July 29, 2015

Re: Arborist Review Tree Permit #2015-ARP-0012, Review and Recommendations
Site: Miles property, 3832 NE 155th St., Lake Forest Park, WA 98155

**ATTACHMENT: 2013 AERIAL SITE PHOTO
3832 NE 155th St.
Lake Forest Park, WA**

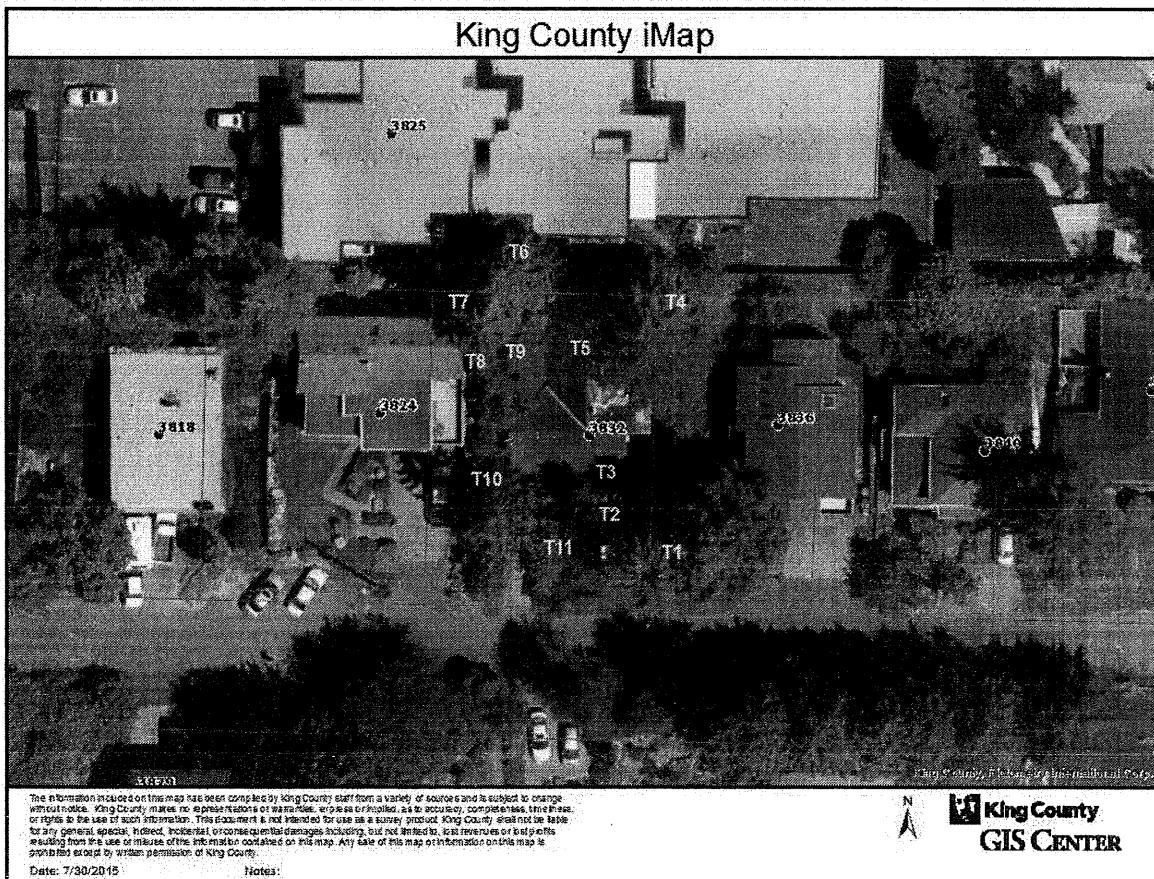
Trees numbered 2, 3, 9 and 11 are recommended for removal. They cannot be adequately protected from the proposed demolition activities or they are in poor health and condition and unworthy of long term retention. Tree 1 is located in the right-of-way of the overhead electric power lines(OHP). It was topped in the past for line clearance and now has multiple top leaders, a structural tree defect which makes failure more likely. There are available mitigation options to reduce risk, such as crown thinning and cabling. The tree is expendable, in my opinion, considering its location and potential for future conflict with the OHP. The crown of Tree 10 has thinning and fading foliage and appears to be in decline. It is located at the edge of the compacted driveway and I suspected root damage or root disease is creating the stress to the tree. The tree is expendable, in my opinion.

Locations of inventoried trees.

<u>Trees recommended for removal:</u>	<u>Trees to retain:</u>
T1	T4
T2	T5
T3	T6
T9	T7
T10	T8
T11

Trees numbered 4- 8 have the potential to be retained. They are generally in good overall health and condition and are suitable to tolerate the demolish work or construction activities. Activities impacts can be minimized by following the recommended tree protection measures, see *Attachment: Tree Protection Measures*.
